Access Compliance Report Public Rights-of-Way (Curb Ramps)

Main Street: WINDSOR_PL Cross Street: 17TH_ST Location: SW

ADA ID: RPRK211008124158 Ramp Type: Type 7 - Directional 2 Initial Pass/Fail: Fail Overall Compliance: No Severity Score: 16

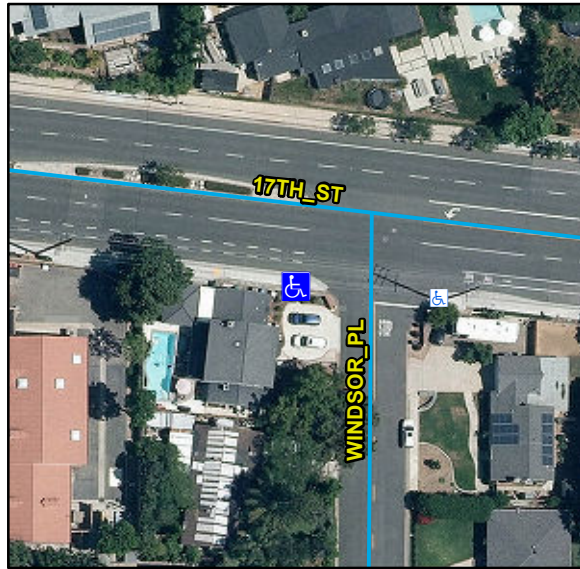
R304.2.2, R304.5.3, STD 1115

Remove & Replace Entire Ramp.
